ALCE PRO SUBDIVISION

APPLICATION NUMBER 17 DATE January 16, 2014

REQUEST Subdivision

DETAIL SITE PLAN

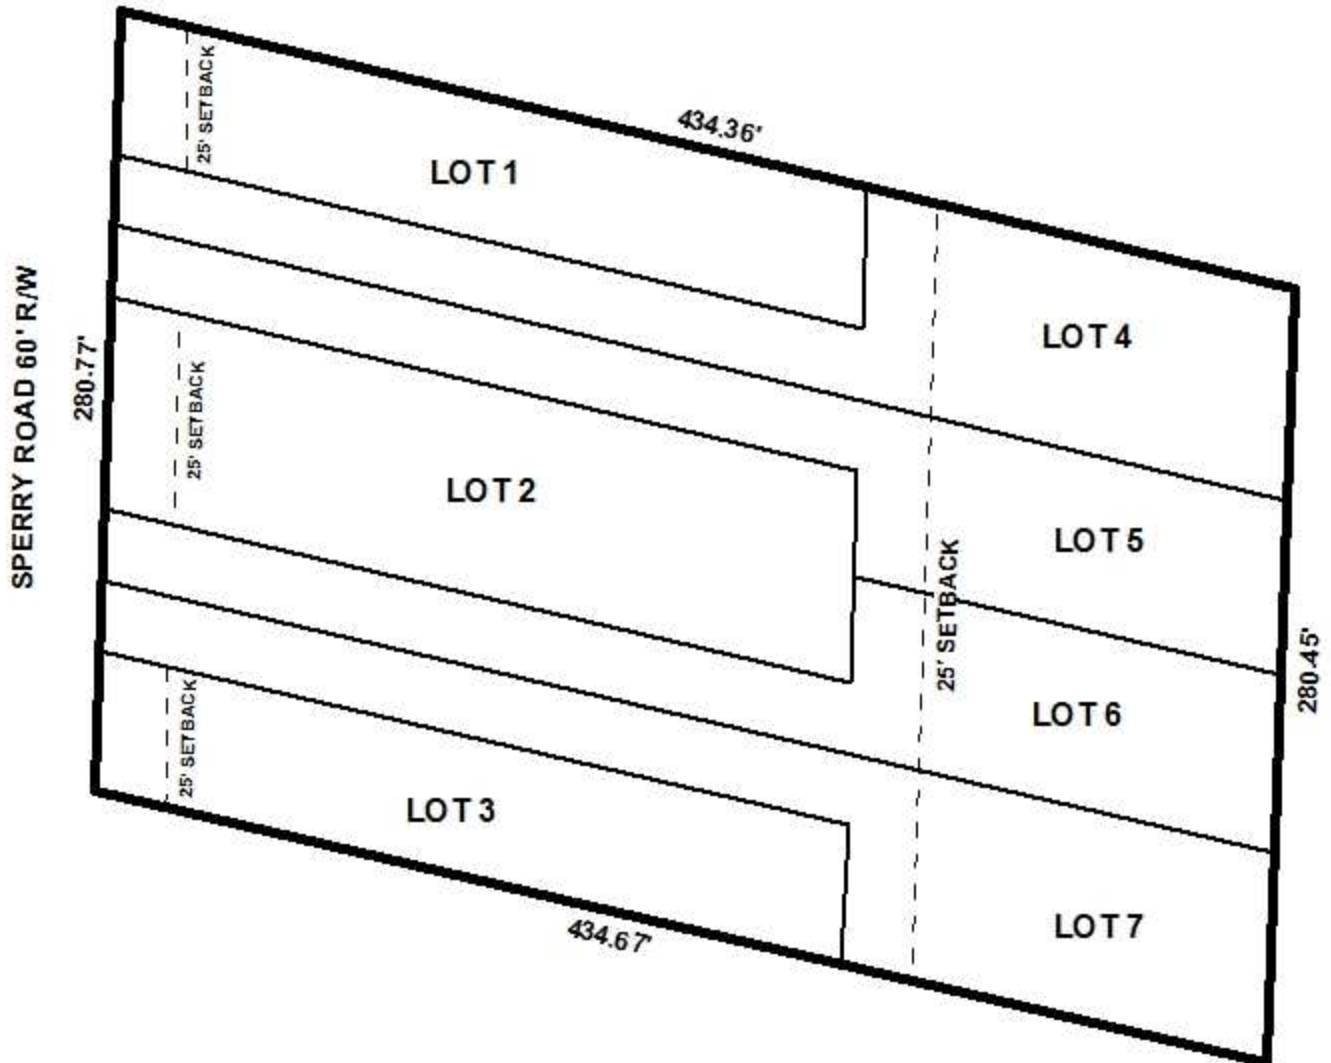
While the 4 proposed flag lots meet the minimum 25 feet width for the “pole” and comply with section V.D.1 and V.D.2 there are no found natural or pre-existing man-made barriers which may cause an undue hardship on the land owner. Nor is a flag lot necessary to allow the site’s owner reasonable use of the site or to alleviate a situation that would otherwise cause extreme hardship. If the 7 proposed lots were reduced to 2 lots all subdivision requirements would be met and a waiver of Section V.D.1 and V.D.3 of the Subdivision Regulations would no longer be needed. It appears the applicant may be utilizing flag shaped lots to avoid the construction of a street with a cul-de-sac, and may be excessively subdividing the site. However if approved a waiver of Section V.D.1, and V.D.3 will be required.

Section V.D.2. of the Subdivision Regulations states “lots for residential use shall be at least 60’ wide at the building setback line” and must be a minimum lot size of 7,200 square feet for lots served by public water and sanitary sewer. The preliminary plat depicts Lot1 and Lot 3 as being only 50’ wide, thus a waiver of Section V.D.2 would also be required, if approved.

As access management is a concern, Lots 1, 2, and 3 should be limited to one curb cut each, to Sperry Road. Lots 4 and 5 should be limited to one shared curb cut and Lots 6 and 7 should be limited to one shared curb cut with the size, location and design of all curb-cuts to be approved by Mobile County Engineering and conform to AASHTO standards.

It should be noted the plat is not printed to scale. If approved, the Final Plat should be printed to a standard engineering scale.

- 1) the applicant's justification for the creation of 4 flag lots is based off the opinion that the property is irregularly shaped;
- 2) lot 1 and lot 3 do not meet the minimum 60' lot width as required by Section V.D.2; and
- 3) the applicant appears to be over subdividing the site in order to maximize the number of lots and avoid construction of a road.
